To the New Hampshire DOT,

the Easton Selectboard received a letter from Melodie Esterberg on September 30<sup>th</sup> 2016 responding to Selectboard questions regarding Northern Pass geotechnical boring. I request a more thorough and detailed response to the Board's questions and pose more questions.

TYPICAL HDD LAYOUT ON CSX ROW  
BI-POLE (2 CABLES) ONE SIDE OF TRACK

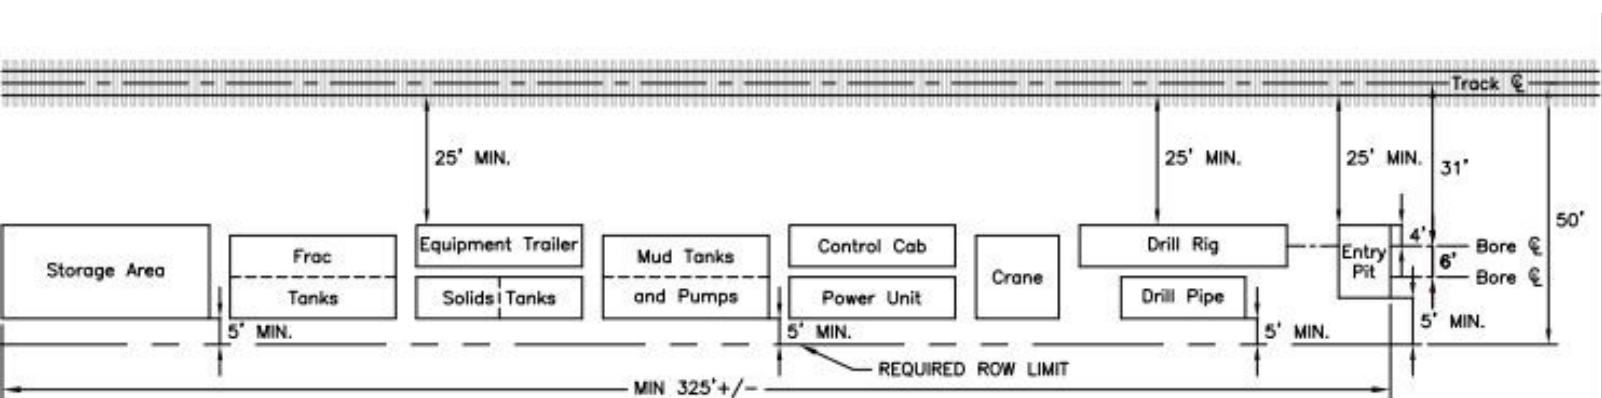
3. There is no width of easement so narrow that construction would be denied outright, despite the DOE's Environmental Impact Statement on width requirements for HDD:

materials storage. It is likely that previously disturbed areas would be utilized to the maximum extent possible, for the purposes of analysis it was assumed that an area 100 feet by 200 feet (30 m by 61 m) would be cleared of vegetation and soil would be disturbed at each end of every trenchless segment. A trenchless excavation pit approximately 20 feet wide, 20 feet deep, and 60 feet long...would be required paralleling the alignment at the start and end of each trenchless segment.”

“Short term disturbance for the trench and construction activities is assumed to be 10 feet (3 m ) wide, with the majority of disturbance limited to the road surface (approximately 30 feet ( 9m ) wide) and adjacent, previously disturbed areas.” In Easton large areas of the road surface are 12' wide, with an additional 8' of often undisturbed area.
